UNITED STATES  
NUCLEAR REGULATORY COMMISSION  
WASHINGTON, D. C. 20555

INDIAN POINT NUCLEAR GENERATING UNIT NO. 2

AMENDMENT TO FACILITY OPERATING LICENSE

Amendment No. 20  
License No. DPR-26

FIGURE 2.1-1

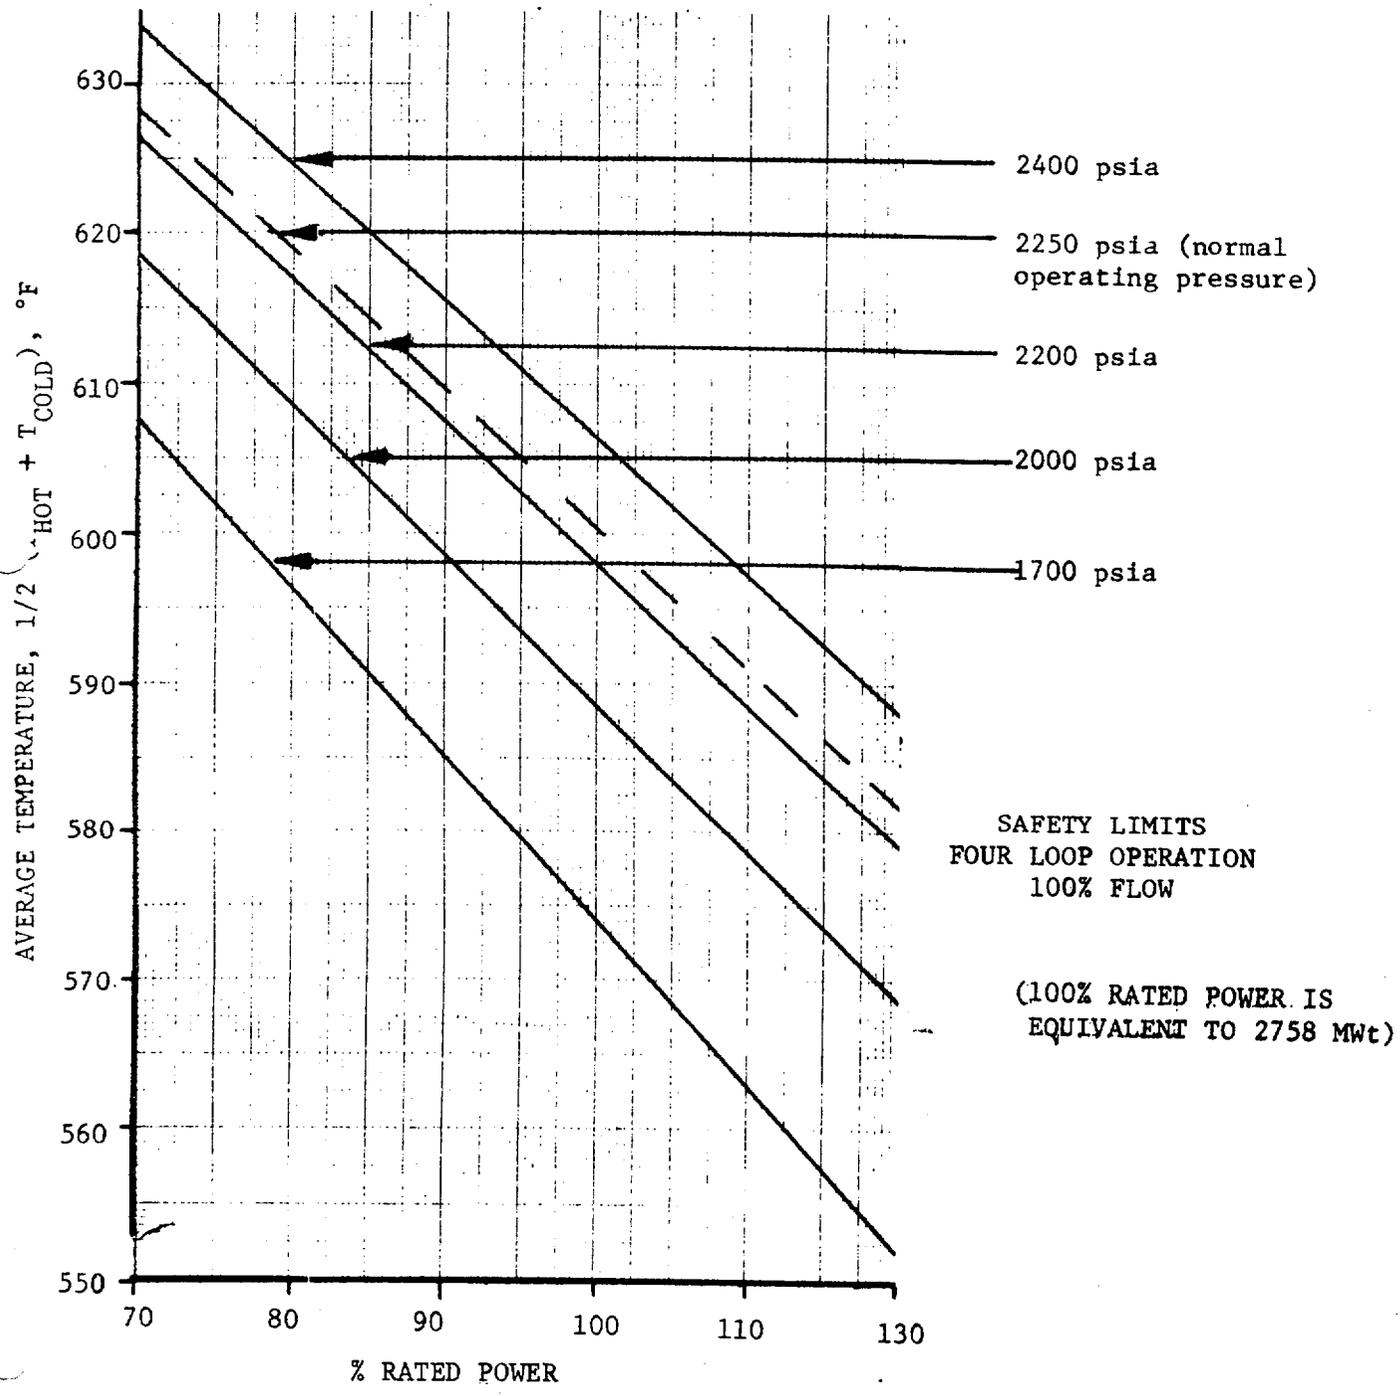
The curves of Figure 2.1-1 and 2.1-2 represent the loci of points of thermal power, coolant system pressure and average temperature for which the DNBR is no less than 1.30. The area where clad integrity is assured is below these lines.

Figure 3.10-1

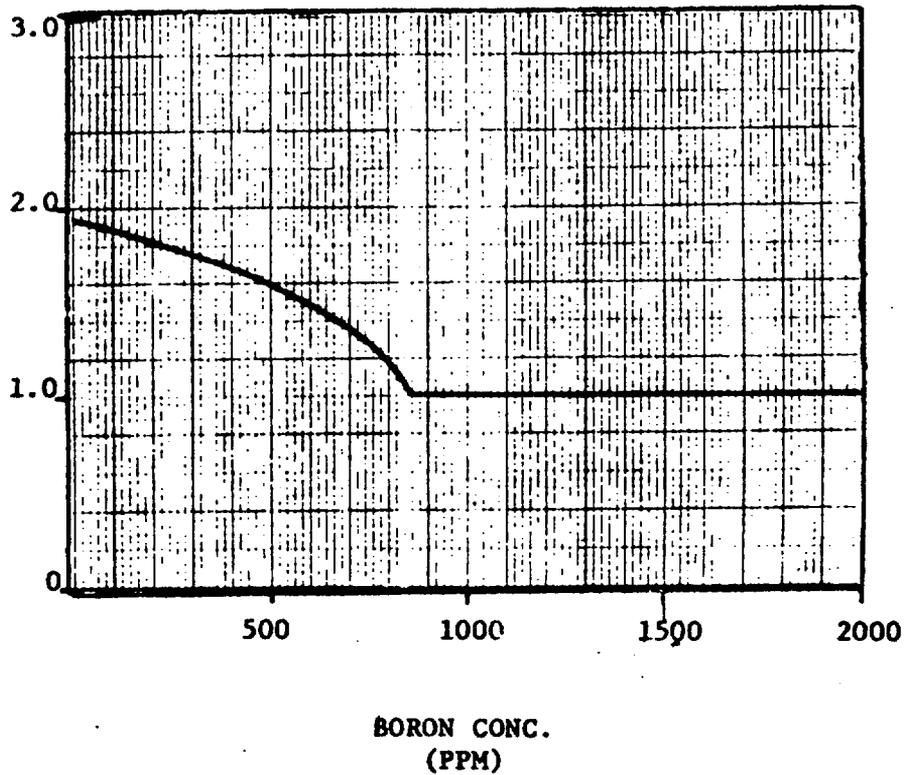
The shutdown margin shall be at least as great as shown in Figure 3.10-1.

Trip shutdown reactivity is provided consistent with plant safety analysis assumptions. One percent shutdown is adequate except for steam break analysis, which requires more shutdown if the boron concentration is low. Figure 3.10-1 is drawn accordingly.

Figure 3.10-2

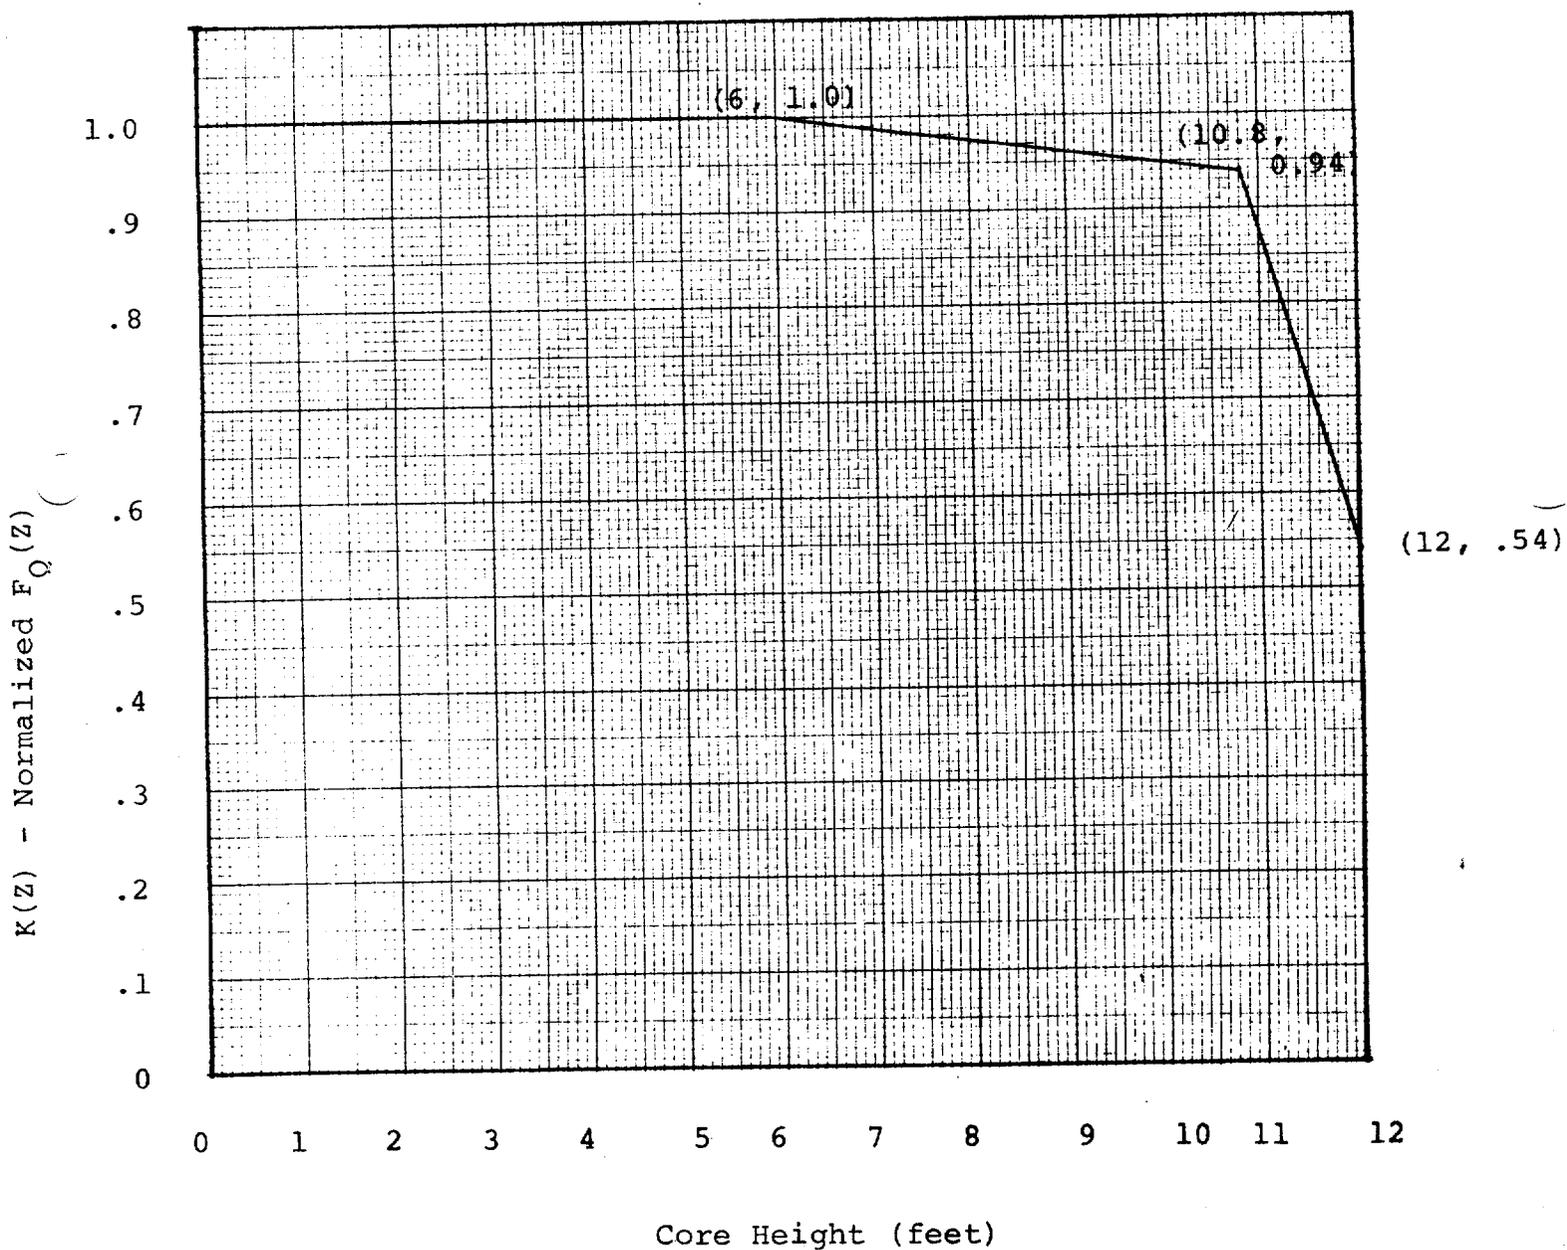
where P is the fraction of full power at which the core is operating.  
K(Z) is the fraction given in Figure 3.10-2 and Z is the core height location of  $F_Q$ .

An upper bound envelope of 2.32 times the normalized peaking factor axial dependence of Figure 3.10-2 has been determined from extensive analyses considering all operating maneuvers consistent with the technical specifications on power distribution control as given in Section 3.10. The results of the loss of coolant accident analyses based on 2.32 times the normalized envelope of Figure 3.10-2 indicate a peak clad temperature of 2115°F for the double-ended cold leg guillotine break with  $C_D = 1.0$ . This corresponds to a 85°F margin to the 2200°F limit. [1]

The technical specifications on power distribution control assure that  $F_Q$  upper bound envelope of 2.32 times Figure 3.10-2 is not exceeded and xenon distributions are not developed which at a later time, would cause greater local power peaking even though the flux difference is then within the limits specified by the procedure.

The licensee proposed to change  $K(Z)$ , the power distribution limit to gain additional operational flexibility for Indian Point Unit 2 Cycle 2. Since the peak cladding temperature developed during small break LOCA is a function of power in the upper region of the core, the small break was re-analyzed to justify the licensee's proposed increase in the  $K(Z)$  limit. Presently referenced on the IP-2 docket is a conservative small break LOCA analysis which was performed at the more restrictive IP-3 operating conditions (see section on ECCS Analysis, pages 2 and 3). The licensee reanalyzed the 4, 6, 8, and 9.57 inch diameter break sizes specifically for the IP-2 plant using the approved versions of the WFLASH and LOCTA -IV computer codes in accordance with Appendix K to 10 CFR 50. A core power distribution was assumed that was skewed toward the top of the core to maximize the calculated peak cladding temperature. The results of this analysis,

Figure 3.10-3

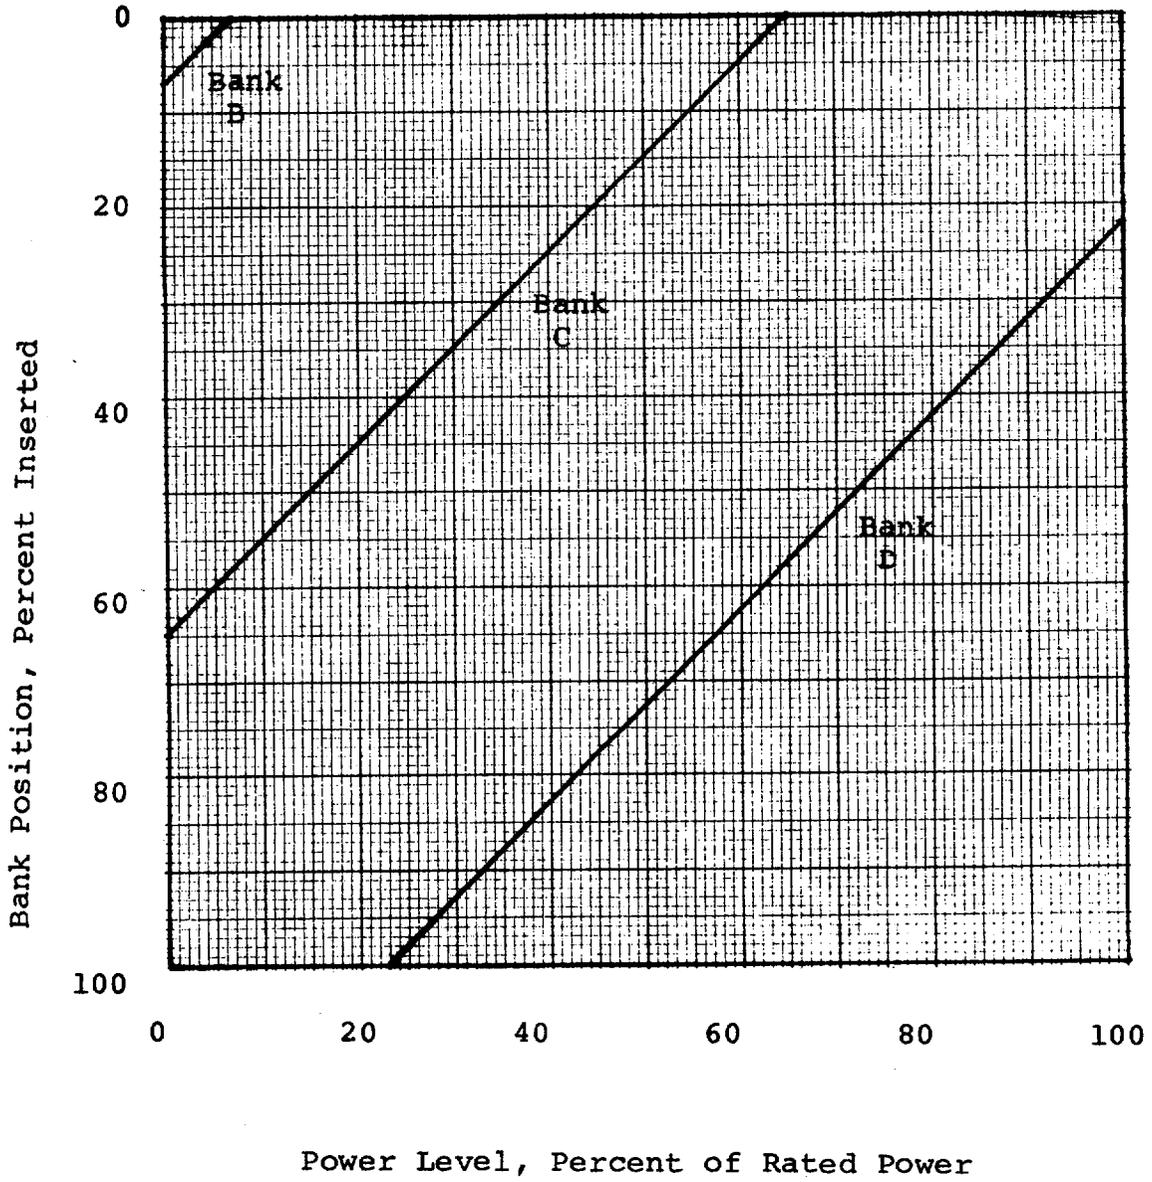
3.10.4.2 When the reactor is critical, the control banks shall be limited in physical insertion to the insertion limits shown in Figure 3.10-3 or Figure 3.10-4.

Figure 3.10-4

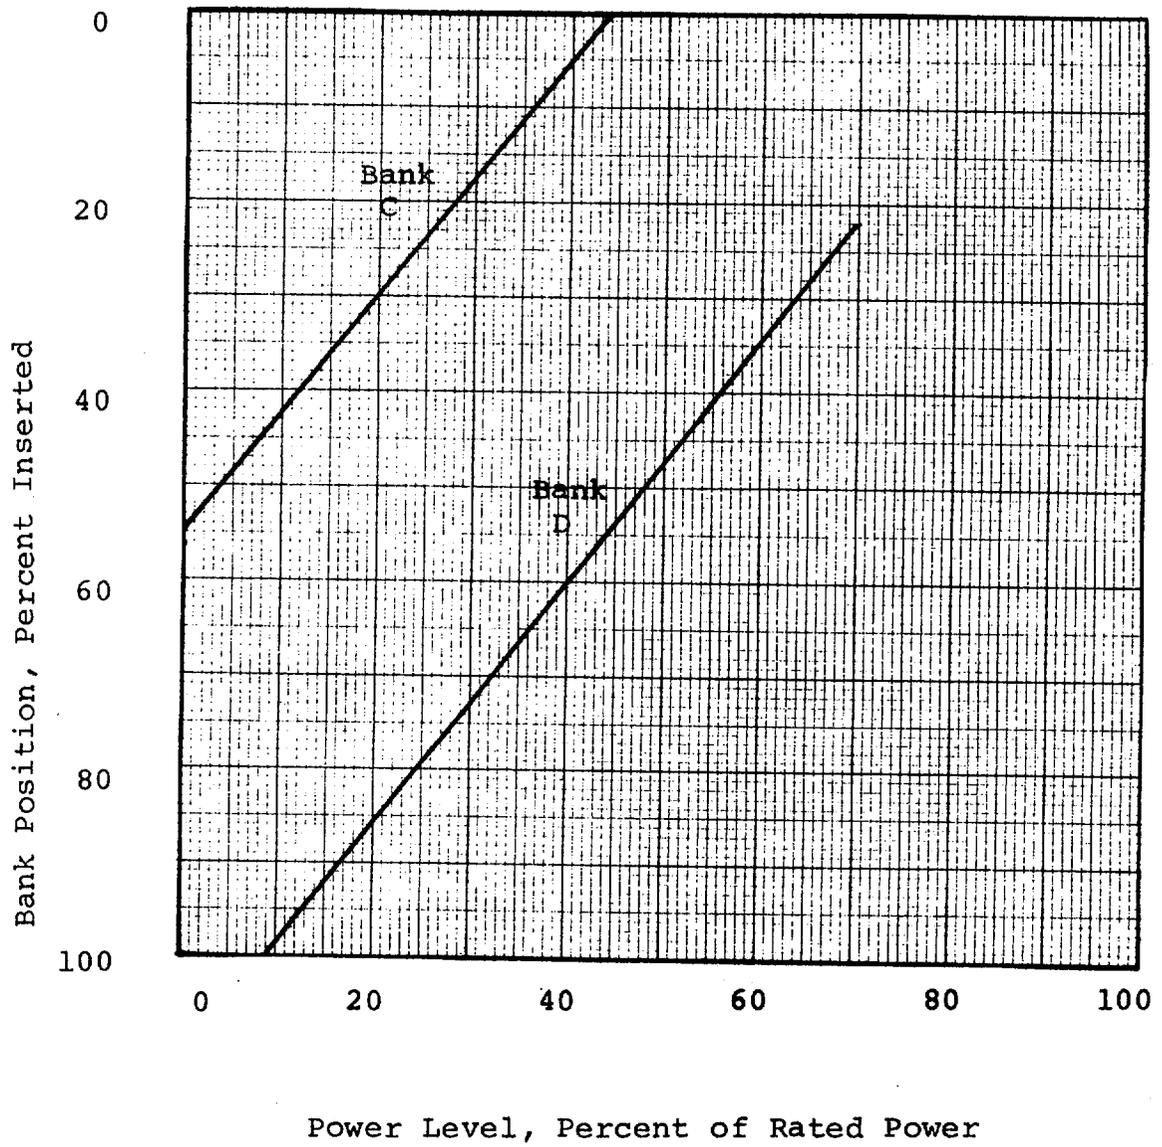
These limiting hot channel factors are higher than those calculated at full power for the range from all control rods fully withdrawn to maximum allowable control rod insertion,(3) The control rod insertion limits are covered by Specification 3.10. Higher hot channel factors could occur at lower power levels because additional control rods are in the core. However, the control rod insertion limits dictated by Figure 3.10-3 insure that the DNBR is always greater at partial power than at full power. For three loop operation the insertion limits of Figure 3.10-4 apply.

An evaluation was not provided for ECCS performance during reactor operation with one primary loop out of service. Therefore, continuous reactor operation under such conditions is not authorized. The reactor may, however, operate for periods up to 24 hours with one primary loop out-of-service. This short time period permits corrective action to be taken and reduces the number of shutdowns and is consistent with other Technical Specifications. Appropriate modifications have been made to the proposed Technical Specifications to establish this restriction on three loop operation.
